CITY PLAN COMMISSION STAFF REPORT

Project Name
6500 Troost Avenue

Request
CD-CPC-2023-00002
Rezoning to district UR
Development Plan

Case Number: CD-CPC-2023-00002

A1 LANDSCAPING PLAN
1" = 20'

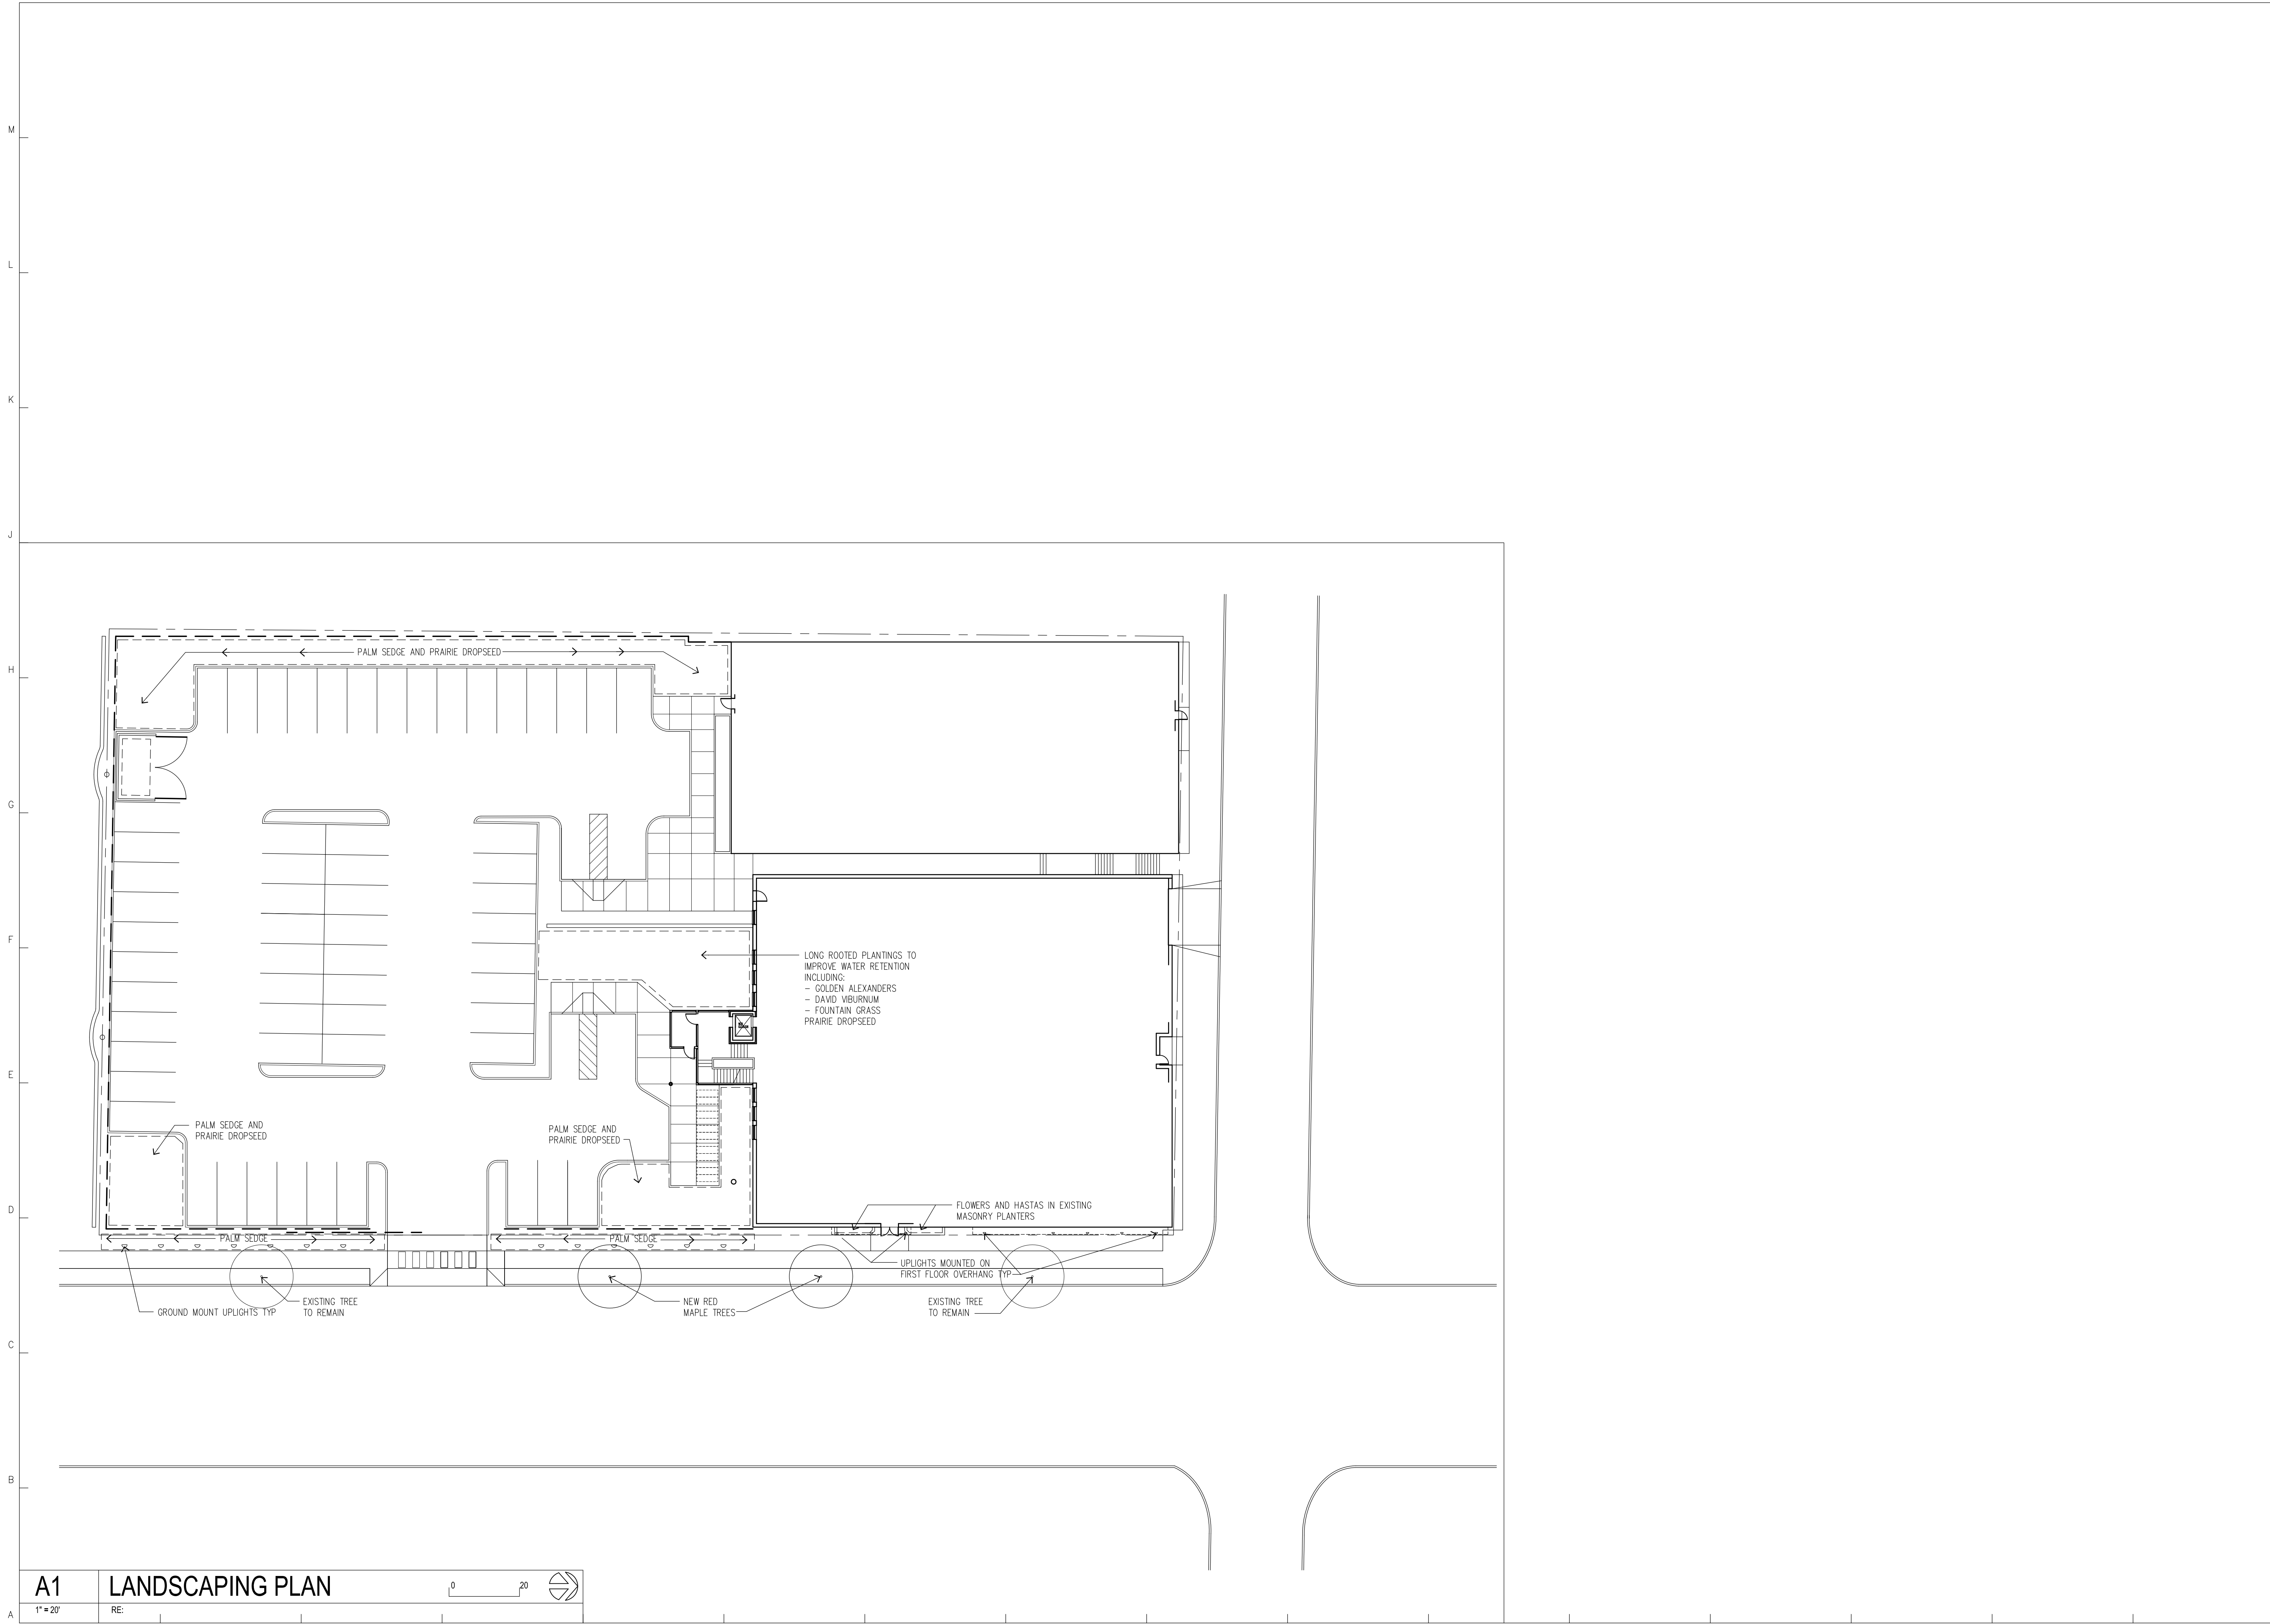
The developer submitted landscaping plans in compliance with the Zoning and Development Code. There is additional landscaping to provide a small buffer between the fence and the right of way. The developer labeled which trees will remain and which will be added to the site on the landscape plan.

The plan clearly identifies the trees to remain and the trees to be added to the site.

1. The developer shall submit an affidavit, completed by a landscape architect licensed in the State of Missouri, verifying that all landscaping required of the approved plan has been installed in accordance with the plan and is healthy prior to Certificate of Occupancy.

J12 PERIMETER GATE ELEVATION

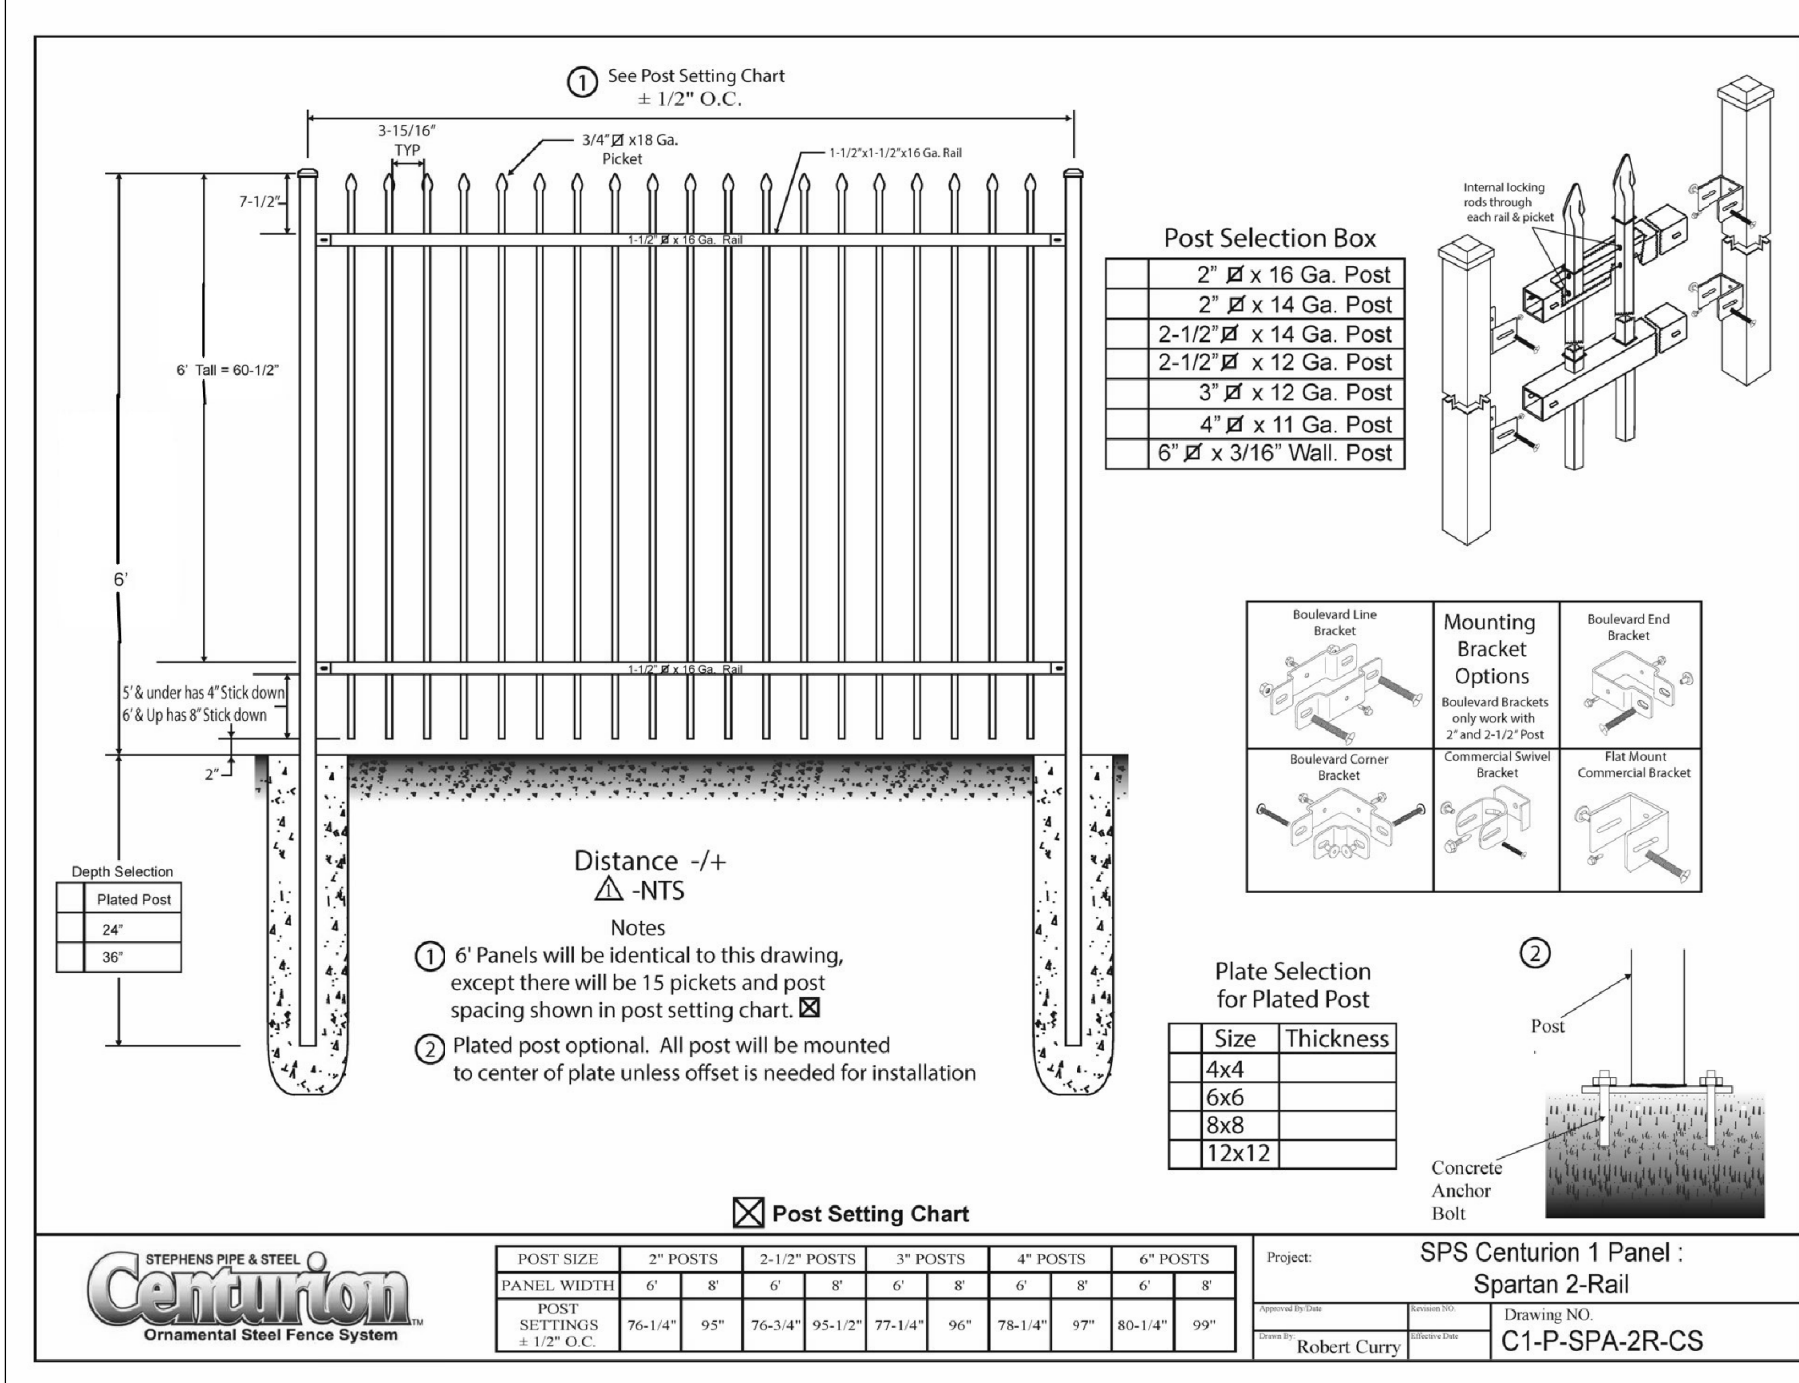
8. If an approved security gate spans across a fire access road, an approved means for emergency operation shall be provided (IFC-2018 § 503.6)

A1 SITE LIGHTING
1" = 20'

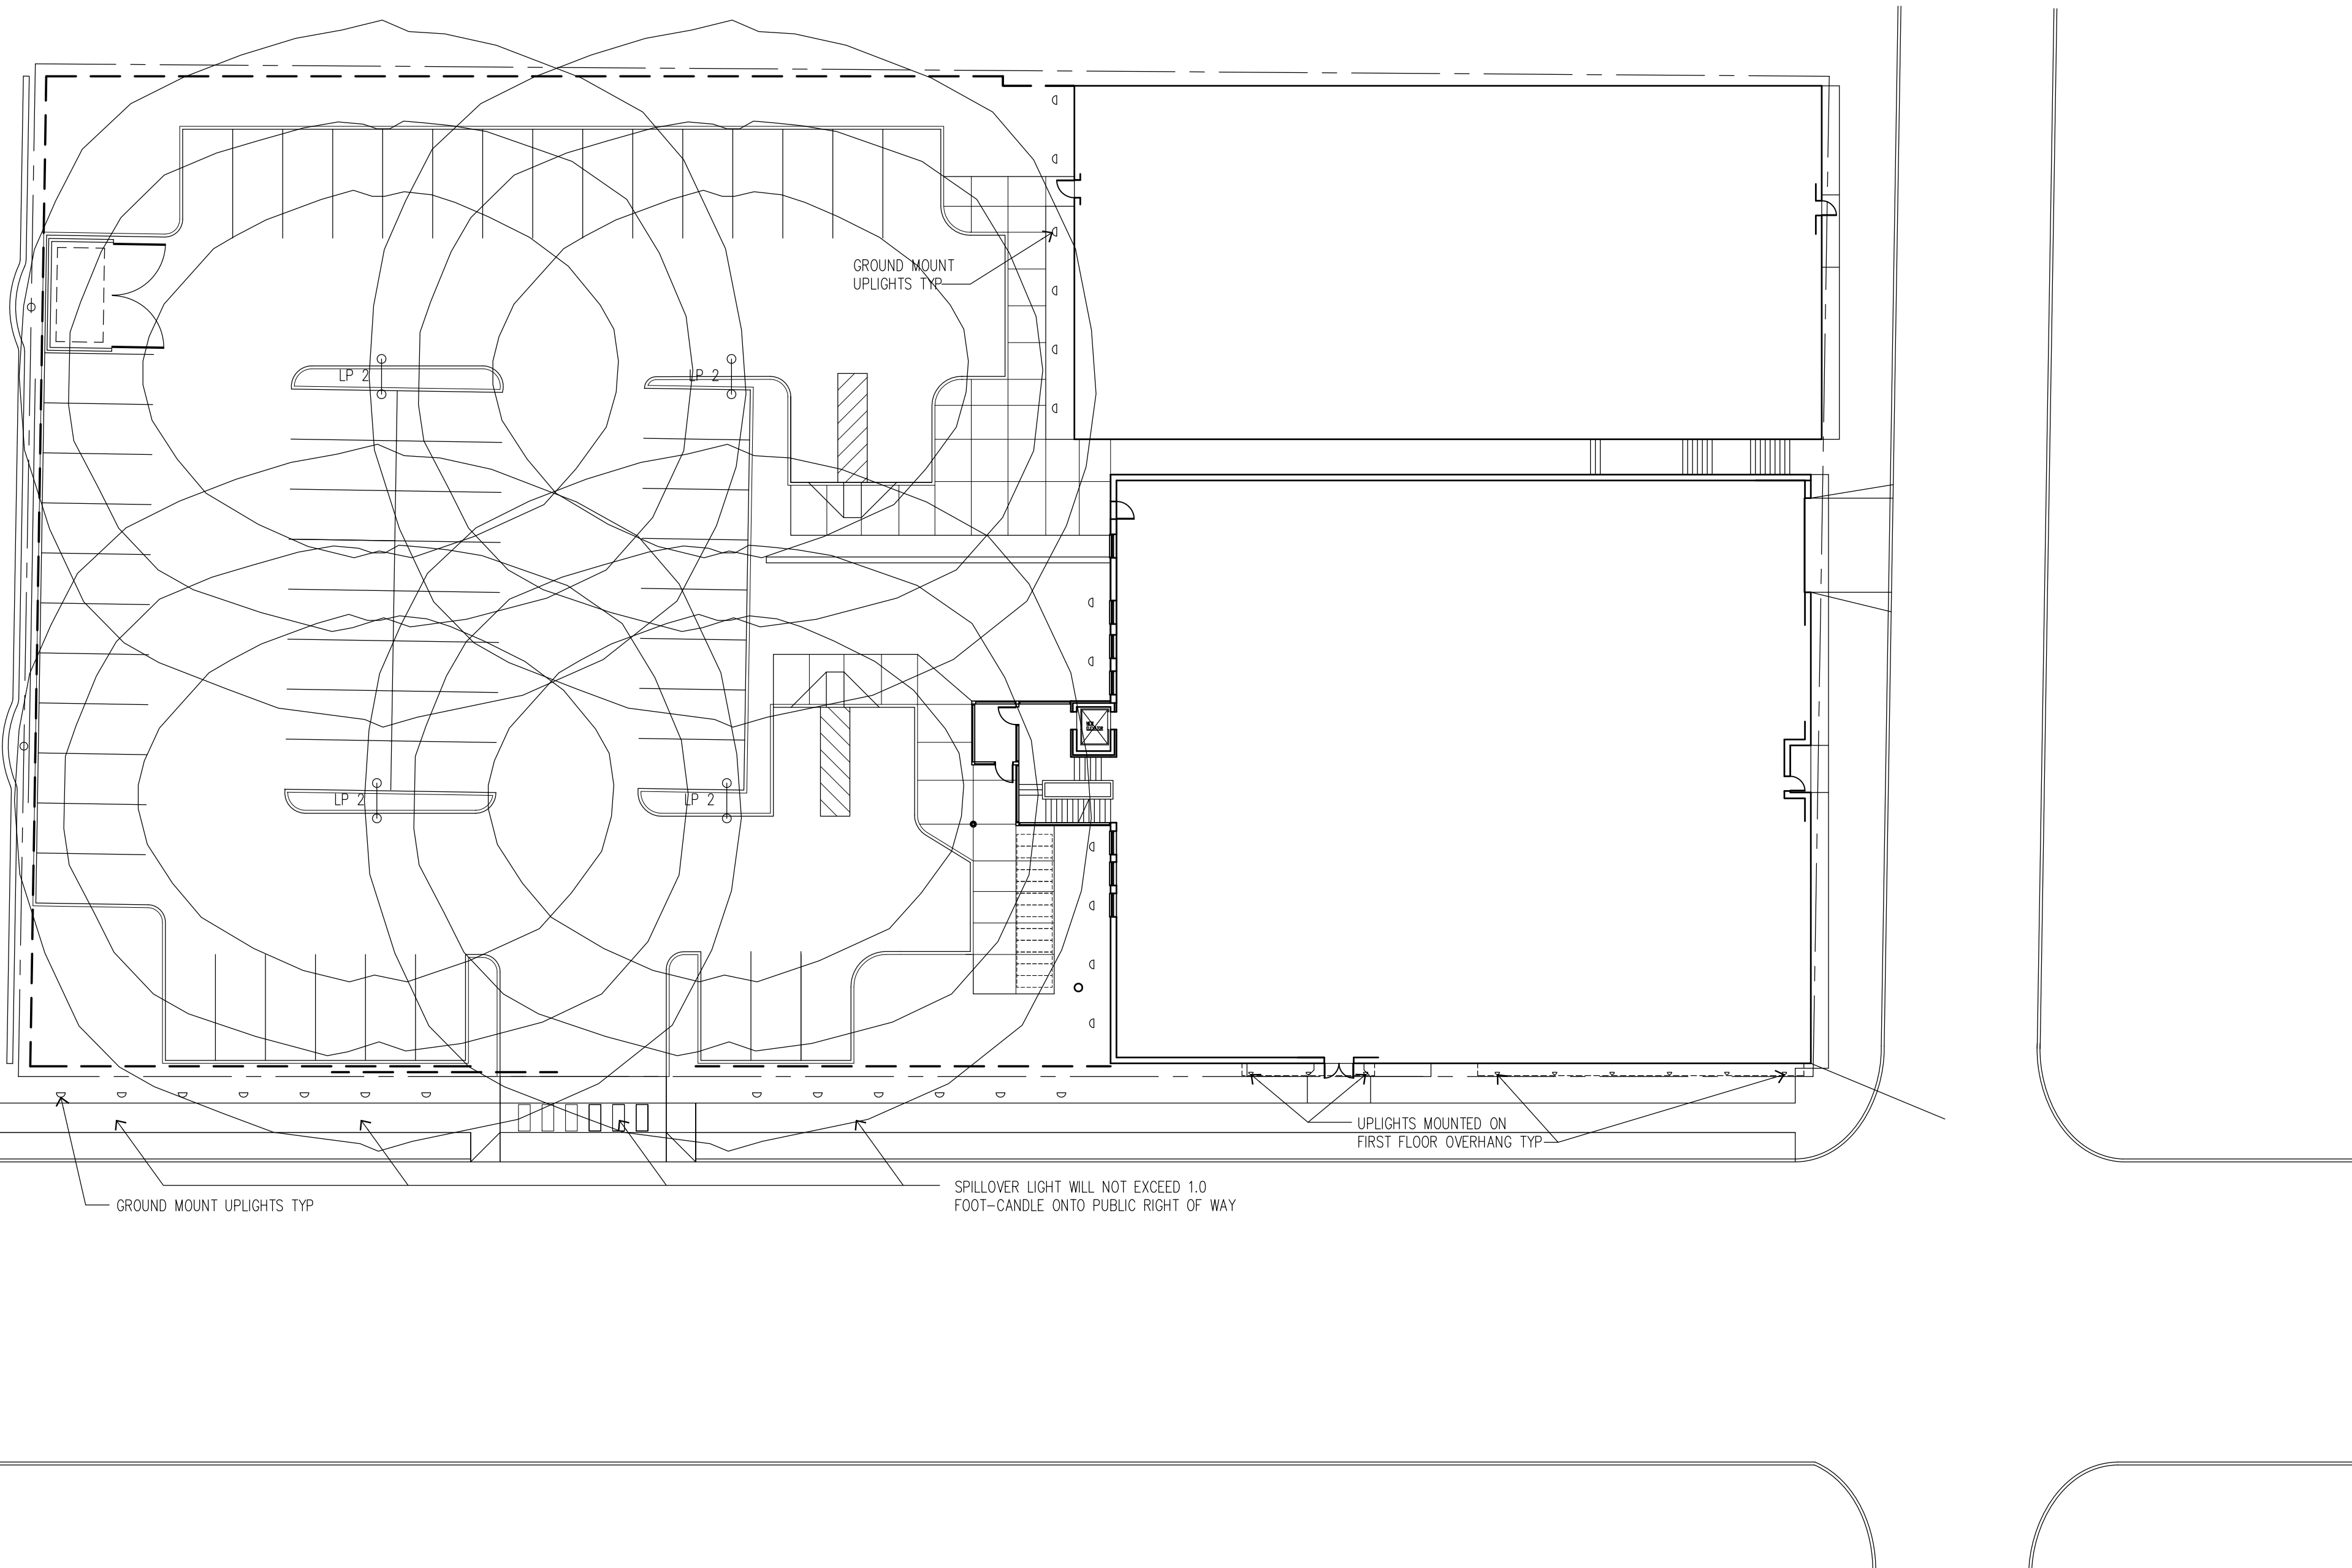
2. The developer shall submit an affidavit, prepared by an engineer licensed in the State of Missouri, verifying that all outdoor lighting has been installed in accordance with approved plans and that lighting levels do not exceed that shown on the approved lighting plan at the property lines prior to Certificate of Occupancy.
